TO: Historical Commission
FROM: Sean Gallegos, Senior Planner
SUBJECT: H23-0001 – 236 Eleanor Avenue

Subject: 236 Eleanor Avenue, Los Altos

Subject: 236 Eleanor Avenue-Response to comments on the Historic Report DPR and Review of Rehabilitation Plans

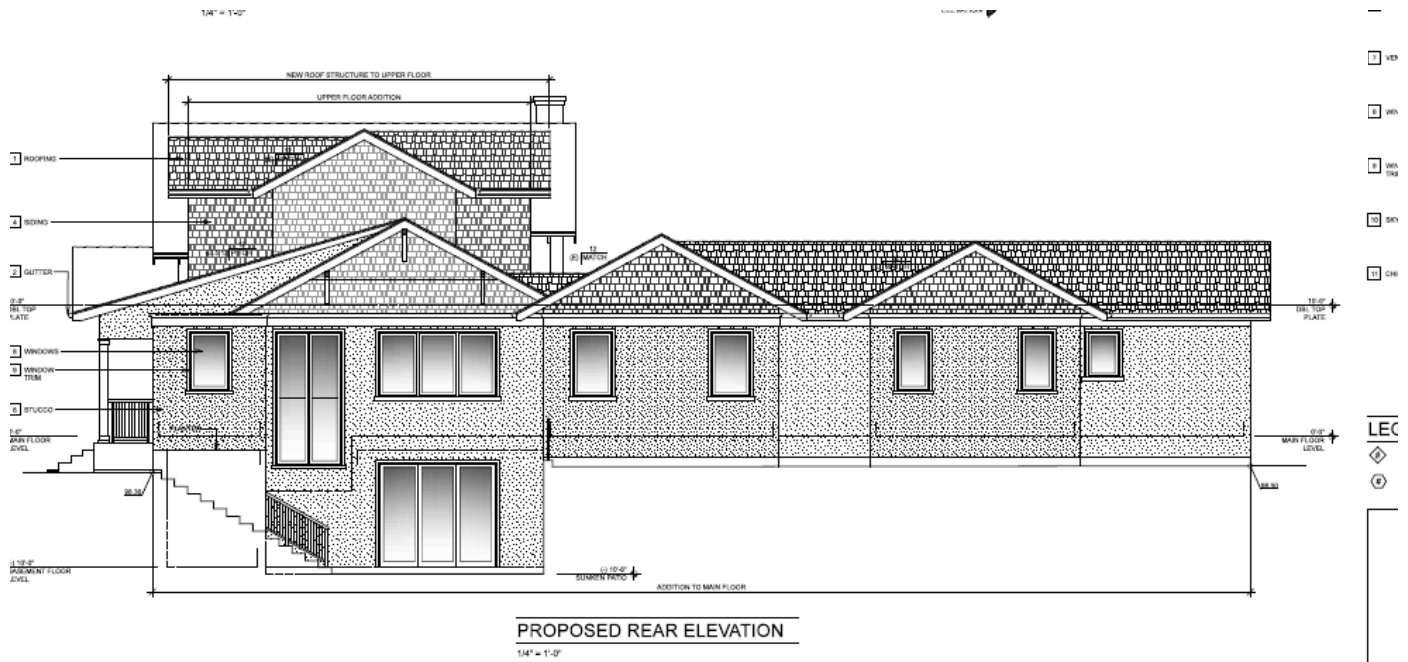
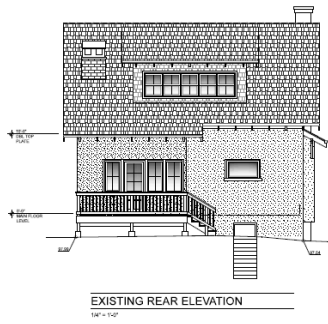
Sean Gallegos. The historian states material textures will be offset or use different texture. Staff has identified stucco will be matching the existing house, and staff does not see the offset or the difference in texture. The historian should provide a greater discussion of the addition not creating a false sense of historic development.

Sean Gallegos. The historian states "the rear are not historically important." Why? If the rear elevation is not historic, the historian must provide a detailed explanation for the reasons under the City's historic preservation standards for the rear elevation not being historically important

In the report, the historian states: "the rear face with the pop-out addition to the original design. The view shows the shed dormer on the rear second level." If the historian does not believe the rear of the elevation is not historic due to addition not being historical significant or a character defining feature in its own right, it must discuss this issue in their response.

While I agree the existing Craftsman design is retained along the front and the majority of the sides. This requires a more detailed discussion than the conclusionary statements (without supporting analysis) which is provided in this response. In your response, you state the stucco is slightly different and differentiates from the historic materials. However, the applicant's materials board shows the stucco will exactly match the existing stucco finish. Therefore, your original statement is not consistent with the proposed plans and materials. Staff requests a discussion of the proposed materials and their consistency under the SOISR.

Urban Programmers Response. Standard 3 and treatments were discussed with the architect Walter Chapman. Textures and colors would be included in the specifications. We did not see the color board. This would have been more appropriately stated that the architect will provide specifications and samples of color and textural differences to be approved by the Planning Staff.

Urban Programmers Response. This should have been explained in more detail as it is above.

Urban Programmers Response. The discussion and explanation of the affected facades is above.

Figure 4 236 Eleanor Avenue- Rehabilitation Plan

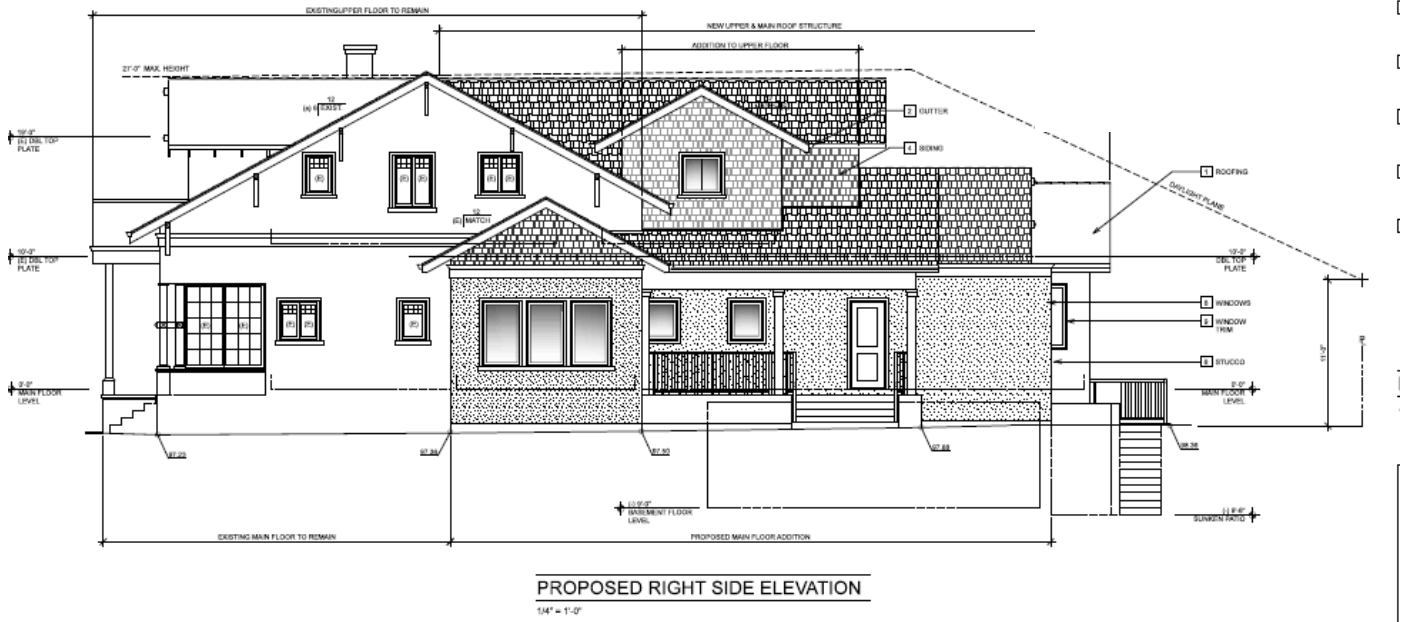
Northside façade historic material and features. The side exhibits character-defining features in the roof slope, fenestration with casement windows exhibiting small panes above a larger pane, and siding. There is a loss of historic material on the side and rear roof framing where the addition connects to the main building; composition roofing materials are not historic and are not character-defining elements. There is also a loss of siding and two plain windows. The loss of historic materials is unfortunate, yet placing the addition to the rear and connecting the roof frame and rear side façades appears to provide the addition with the least loss of historic fabric and features.
